WCAP-14342-A & CENPD-404-NP-A
Addendum 1-A

Optimized ZIRLO™

SUBJECT: FINAL SAFETY EVALUATION FOR ADDENDUM 1 TO TOPICAL REPORT
WCAP-12610-P-A AND CENPD-404-P-A, "OPTIMIZED ZIRLO™"
(TAC NO. MB8041)

Figure 28.4

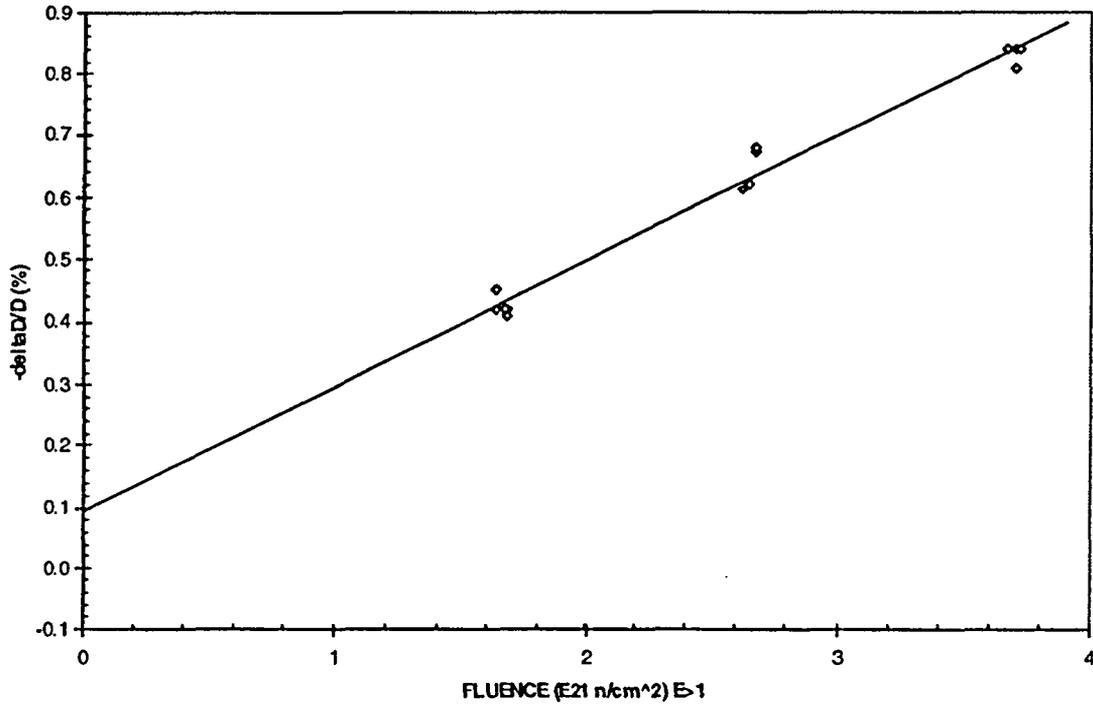
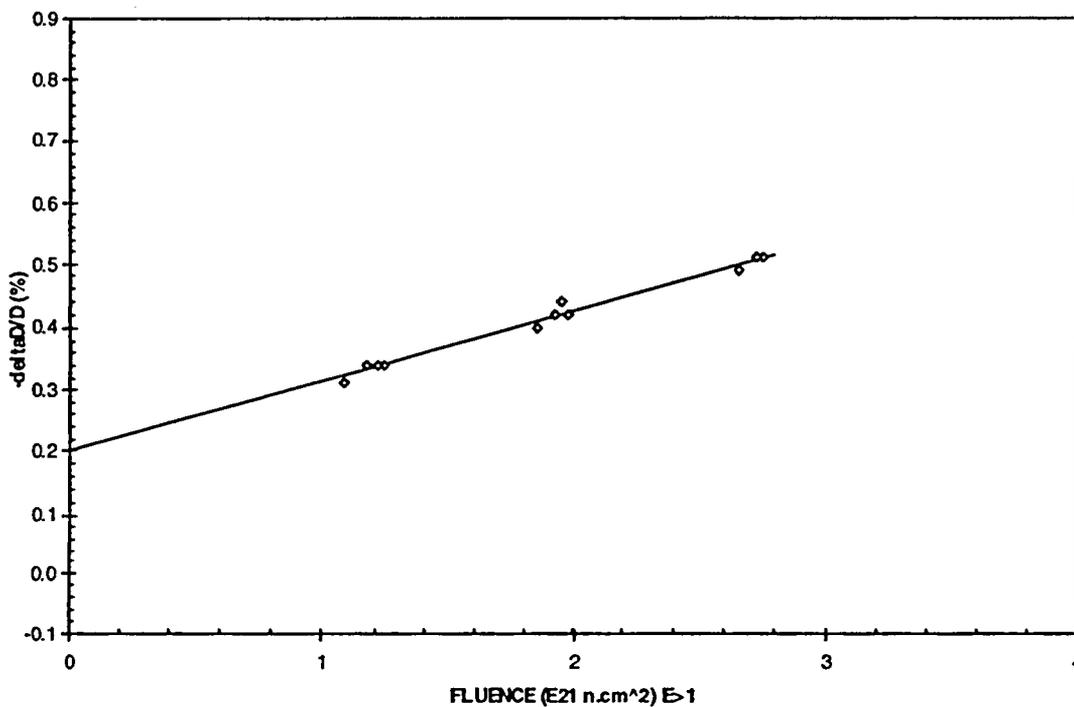
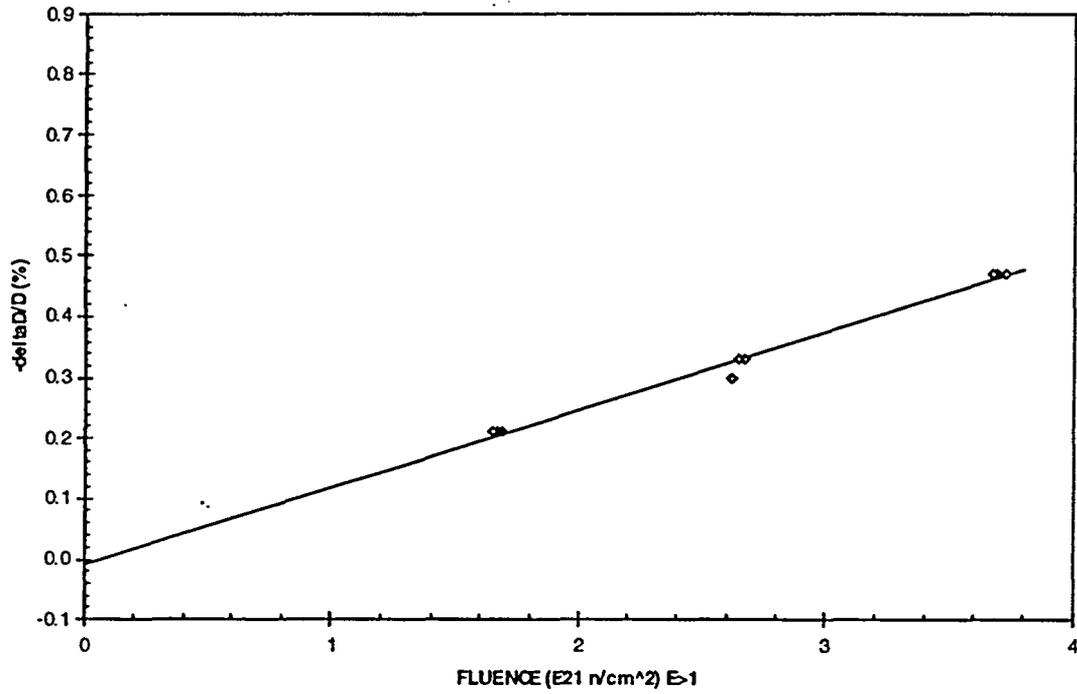
Figures 28.4 to 28.6 present the in-reactor data at a hoop stress of -12.5 ksi (-86 MPa) (Reference 28.3). The out-reactor results were reported as equation correlations (Reference 28.2). Figure 28.7 presents both the in-reactor and the out-reactor data showing the negative of in-reactor creep-down on the y-axis versus the out-reactor creep-out on the x-axis. Note that an increase in out-reactor creep directly correlates with in-reactor creep. This confirms the CWSR ZIRLO BR-3 results.

Figure 1 – Change of 0.2% yield strength by fluence¹¹.

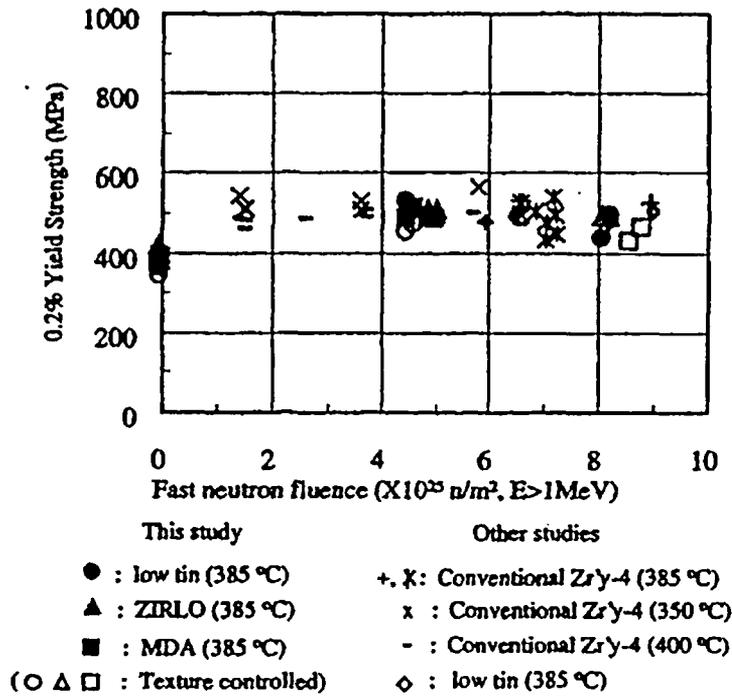
determined in the Thimble Tube Development Program and are given in the above table. These data strongly indicate that the effect of lowering the tin from []^{a,c} has only a very small effect, if any, on the yield stress of the Optimized ZIRLO alloy. The effect is estimated to be less than []^{a,c} at room temperature, and []^{a,c} at 316°C. The small impact of tin on the yield strength of irradiated material is also apparent in hot-cell measurements of conventional and low tin Zircaloy-4¹¹, in which the low tin version of the alloy showed yield strength bounded by the scatter of the conventional tin Zircaloy-4 at a fluence around $7 \times 10^{21} \text{ n/cm}^2$. The same reference also showed irradiation strengthening to saturate at a low fluence of less than $2 \times 10^{21} \text{ n/cm}^2$. A plot of the data is shown in Figure 1.
